**Planning Department Design Review**  
**7 Thornley St, Dorchester**  
**Neighborhood Design Overlay District**  
**12.18.2025**

# RENO OF EXISTING THREE FAMILY HOME

## 7 THORNLEY ST, DORCHESTER, MA 02125

PROPOSED ROOF FLOOR PLAN-  
1/4"=1'-0"

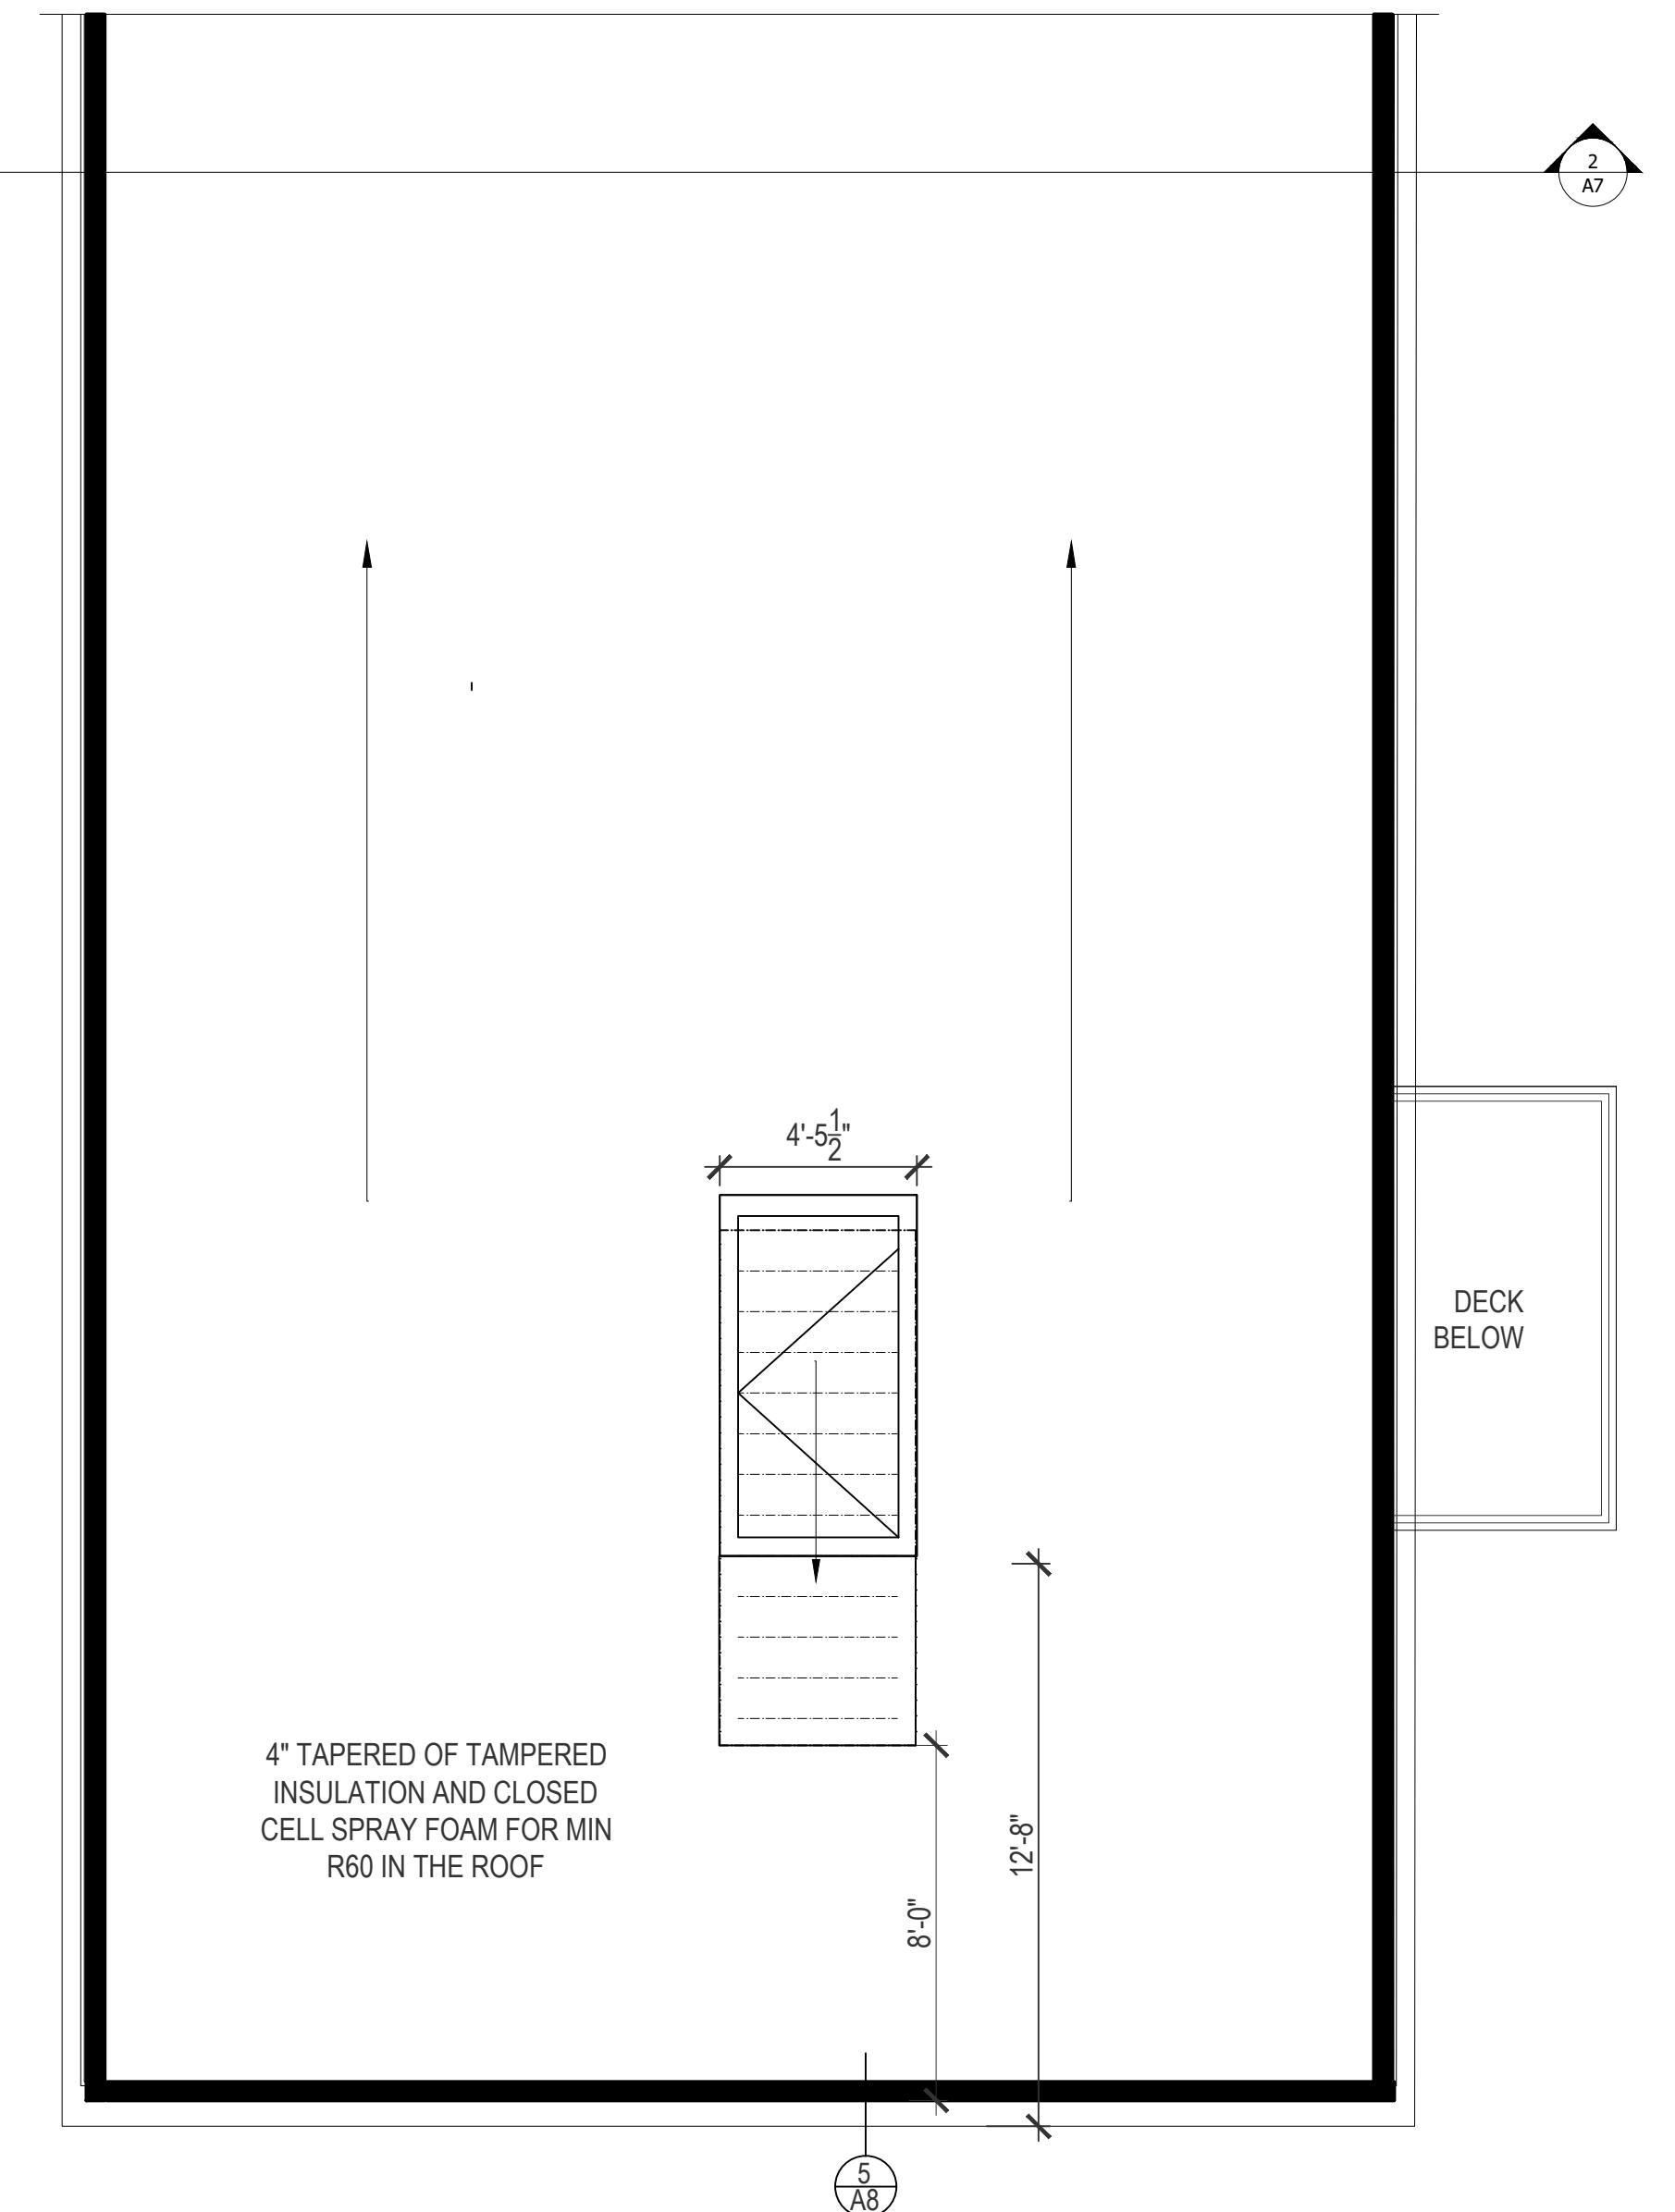
1. Window and door trim shall have the following minimum dimensions: 4" casings with 5" or 6" trim at head. Cornerboards shall be 8" wide at minimum.
2. Create an integrated awning over the front door to shield the entry from weather. Use a solid looking material and finish underneath the entire front porch and stairs.
3. Replace headhouse with a roof hatch.
